RE: Proposed 64E-6.009, ID: 20209870, Volume 44/57

Per our conversation following the hearing yesterday, attached are the written comments received thus far in response to the notice of proposed rule published 3/22/2018 and the public hearing held 4/16/2018.

Presby Environmental, Inc. (PEI) is providing these comments in response to the Notice of Proposed Rule for 64E-6.009 (Alternative Systems) and 64E-6.012 (Standards for the Construction, Operation, and Maintenance of Aerobic Treatment Units) recently published by the Florida Department of Health (FL DOH). Attached please find PEI's comments on individual sections of the rules, as well as general commentary on the subject matter of these proposed rules, below.

Figure 1. In-ground Nitrogen-reducing Biofilter media layer system

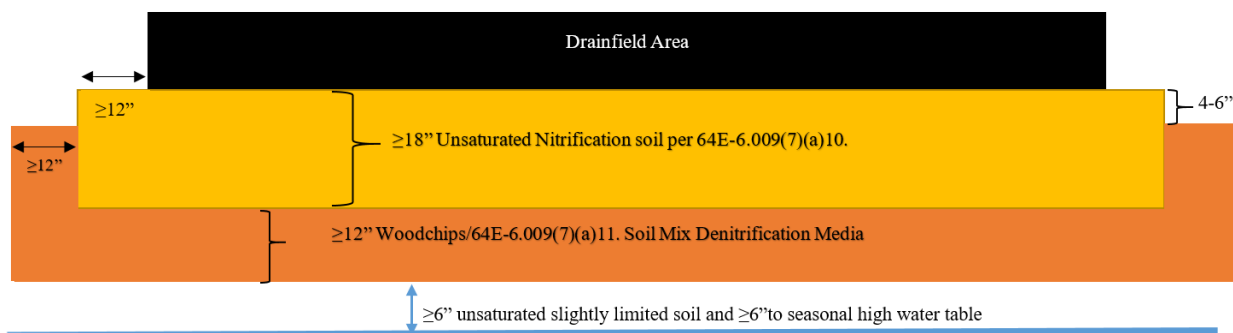
3. The bottom of the media layer shall be at least 12 inches above the wet season water table. (NOTE: change figure beneath woodchips from 6" to 12". Change citations to 64E-6.031(3))
